AGENDA
CITY OF GLENWOOD SPRINGS
Planning and Zoning Commission
Regular Meeting
JANUARY 27, 2026
Council Chambers, First Floor
101 W. 8TH STREET
6:00 PM

Planning and Zoning Commission Staff Report

Date	January 27, 2026
Planning File Number	VAR-000098-2025
Request	Consideration of two Variances (1) for a freestanding sign regarding the maximum height, and (2) number of support poles
Applicant	Bruce Barth, Red House Architecture
Owner	Iron Mountain Hot Springs LLC
Location	281 Centennial Street
Zoning	Resort (RE) District
Staff	Jim Hardcastle, Long Range Principal Planner

Isometric Concept -

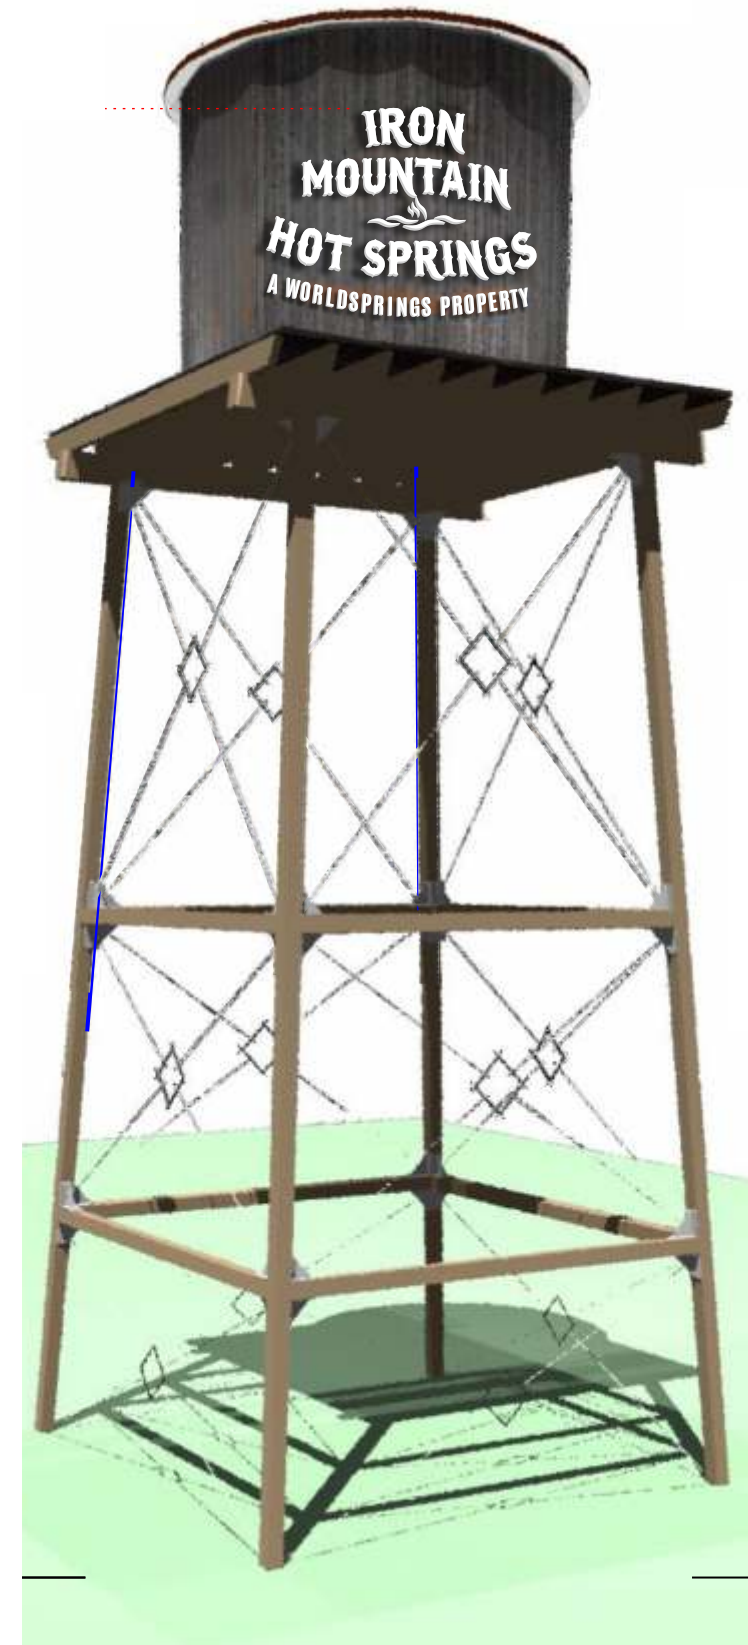
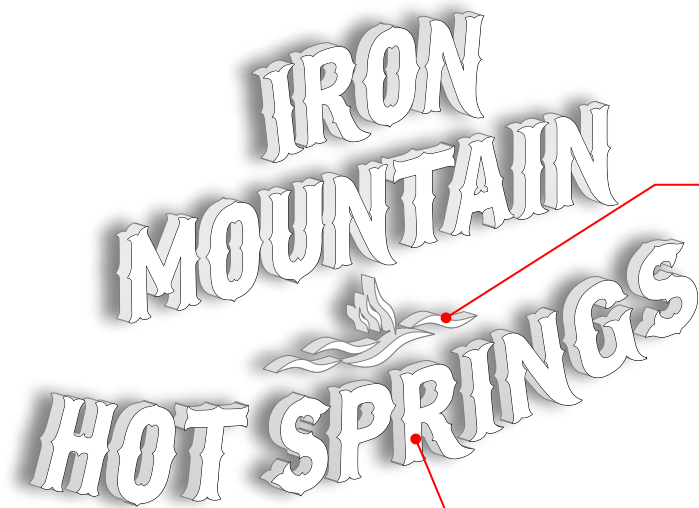
The current Variance application includes a sign designed to resemble a historic water tank tower (see Figure 2 above). Public access to the upper platform is no longer proposed and internal illumination sign lettering is to be mounted directly to the tank portion of the structure. The sign is proposed at approximately the same height as the original design, ranging from 36 to 44 feet. However, staff considers the entire area of the water tank and the platform as part of the sign area, totaling 196 square feet.

Staff’s review of the application considered whether the proposal is a wall sign attached to a building/structure per the Code as opposed to freestanding pole sign. However, attached signs *“[S]hall be located on the side of a building that abuts a street, parking area,*

or other area open to the general public and that has a public entrance to the building” per Section 070.040.110 of the Code. While the tower is a “structure”, it does not meet the definition of a “building” per Section 070.070.030 (applicable definitions are provided in *italics* below). While the sign meets the definition of a structure per Section 070.070.030, it ultimately serves as a freestanding pole sign since the advertisement is not attached to a building nor does the structure provide a public entrance. The total height of the sign structure is 47’-2”. The four poles supporting the tower are part of the sign structure. Per Section 070.070.030(h)(3)c.2, “[P]ole signs shall incorporate a single pole as support.”

At more than twice the height allowed with the RE zone district and four times as many support poles, the proposal does not seem appropriate in terms of the reasonable limitation otherwise applicable. The proposed sign may negatively impact the City’s design character and appearance and grant a marketing advantage to the applicant.
